Subject: Pre-App Notes | P-21-0135 Normandy Heights

PROJECT: P-21-0135/NORMANDY HOMES

PROJECT DESCRIPTION (as provided by applicant): Second pre-app (original P-20-0034). Confirm sewer capacity at Shaw Rd, verify ROW dedication accuracy, verify frontage requirements along Shaw Rd, revised layout review.

CONCEPT SITE PLAN II

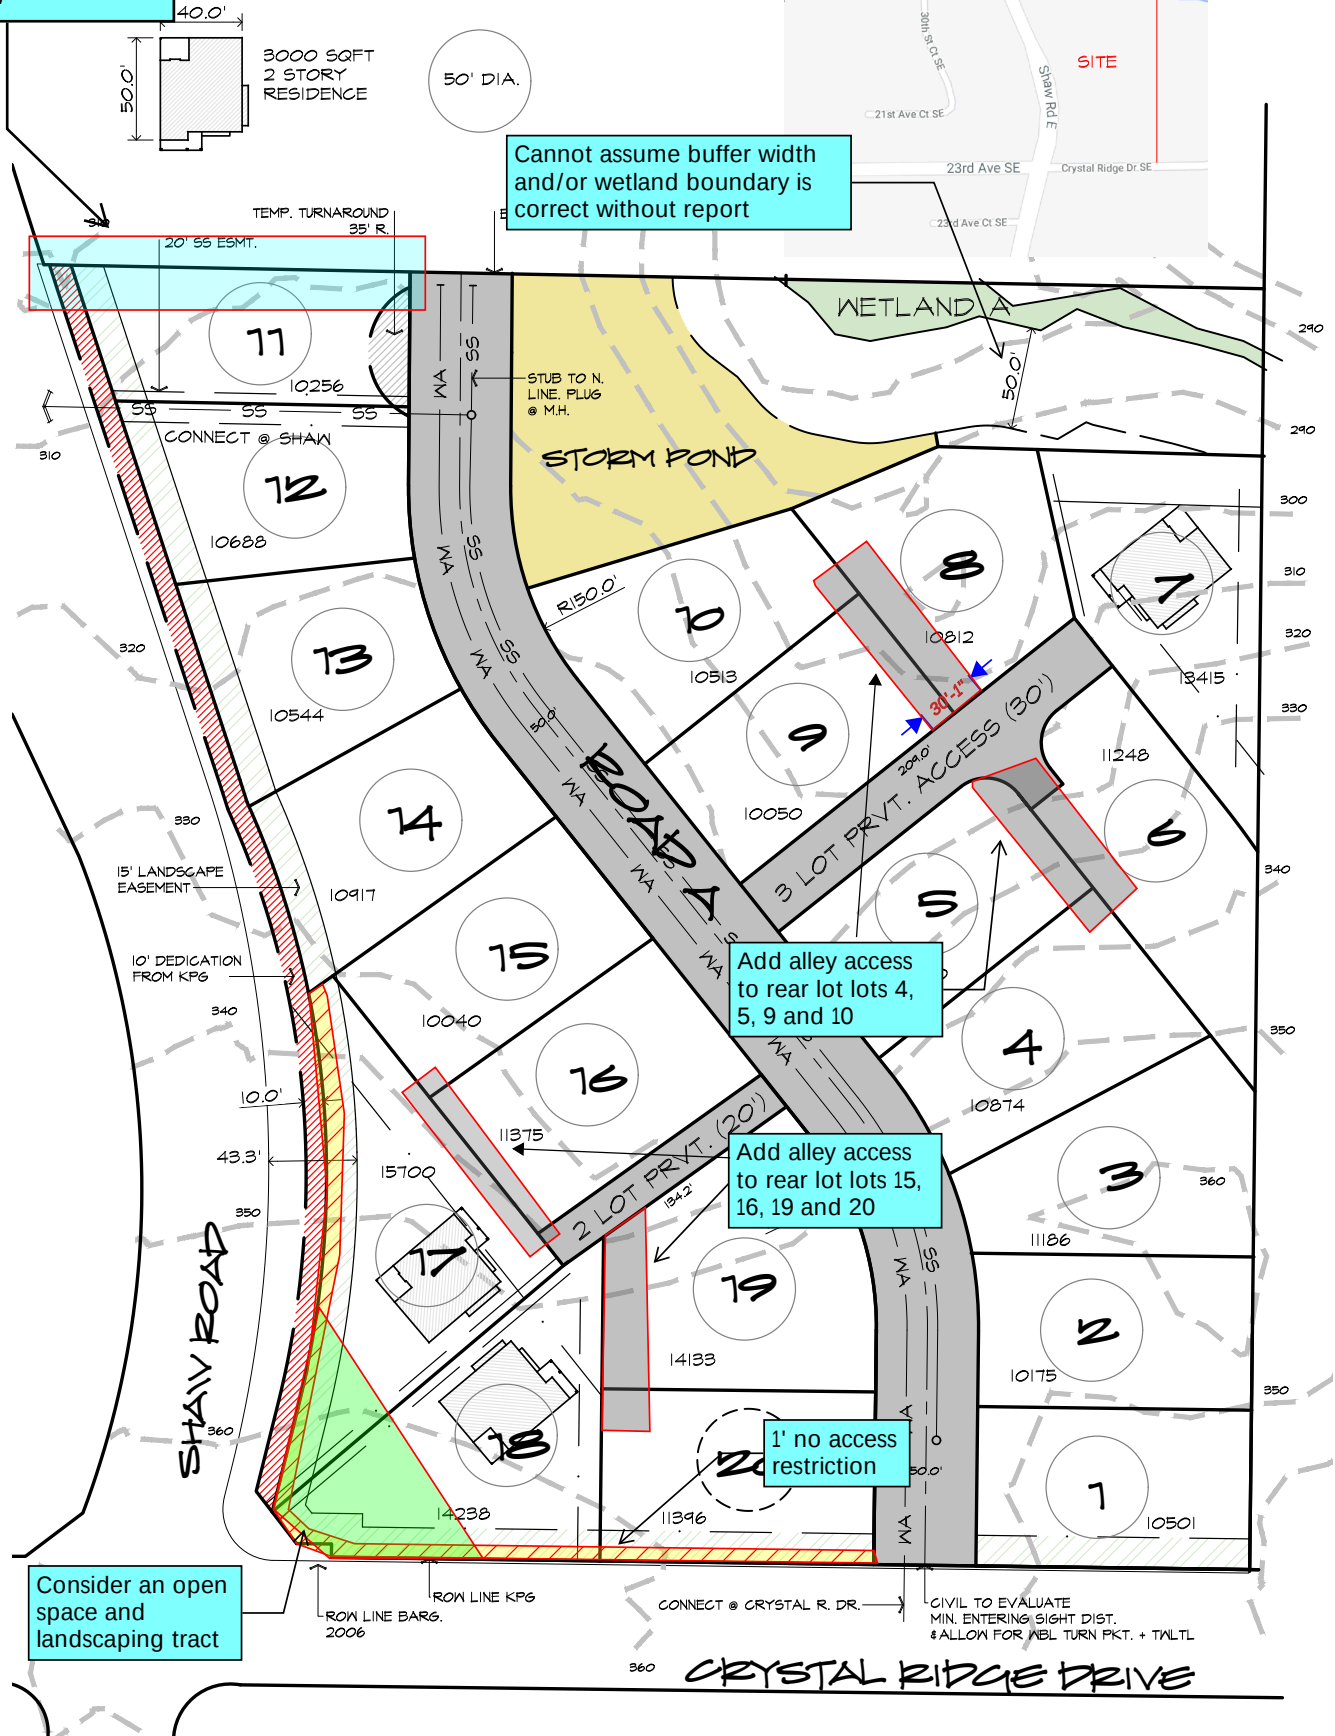
Planning notes
12/09/21

Add ROW alignment for
future intersection at
20th & Shaw

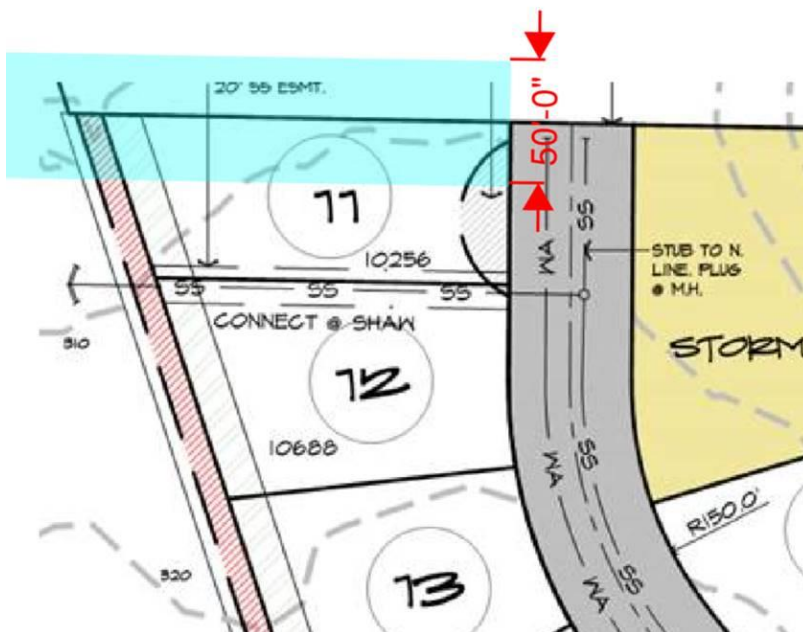
- City will require streetlights along Crystal Ridge frontage.
 - Shaw Road –Required improvements & ROW dedication per Hans Hunger's 12/15/21 email:
"The city is in agreement that obligations for Normandy's frontage improvements along Shaw Road will be met with ROW dedication, rough grading of shoulder area from existing pavement to the proposed retaining walls, and the construction of the retaining walls based on a wall design"

agreeable to the city. It will be Normandy's responsibility to design, permit, and construct the walls as well as implementing any mitigation if any is identified during the permitting process (I'm thinking if the wall design encroached on a wetland). With the fulfillment of these obligations, no further payment of fee in lieu will be necessary."

- City is still working on the final alignment & elevations for the future Shaw Rd section. North of 23rd, the future roadway section will have spiral transitions and will likely be superelevated.
